PRODUCT CHANGE ANNOUNCEMENT

Marathon Special Products is announcing a change in the design of the 143, 144 and 145 series power blocks. This product change is the result of a tooling modification intended to reduce molding maintenance costs and downtime and provide more valued features.

Current Design

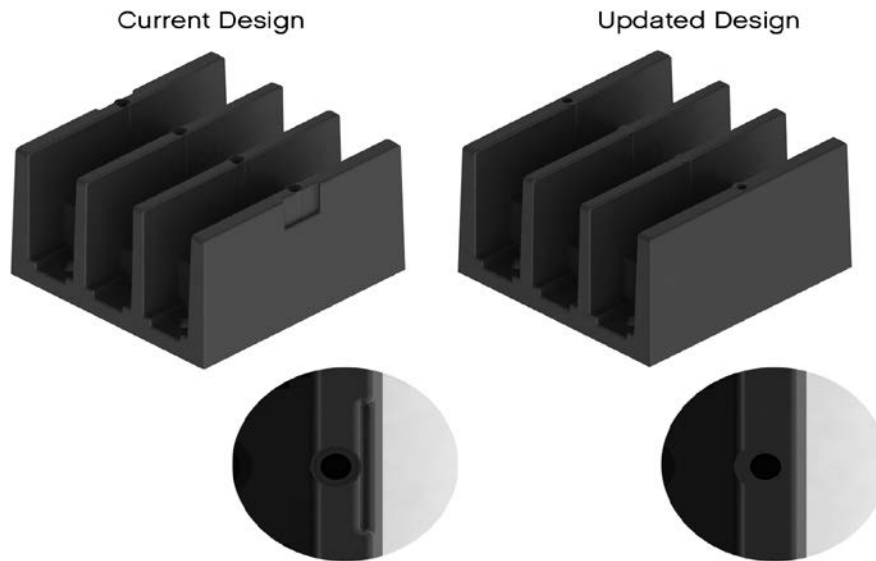
1. Eliminated all non-functional center holes on the top of the power block interior barriers.
 - These holes had no intended function and were not promoted as a design feature of these power blocks. Some utilized them to mount marking strips where they provided a more robust surface area as opposed to the outside top barrier holes, which we have addressed in this design upgrade.
 - Elimination of unnecessary locator pins in the mold will improve production efficiency by minimizing mold maintenance and downtime.
 - In conjunction with Item 2 above, mounting holes in the exterior barriers have been centered in those barriers. This repositioning results in the increased center-to-center hole dimension providing greater strength and product integrity.

This will be a running change with no variance to the part numbers or ratings. The change will be implemented approximately 8/15/19.
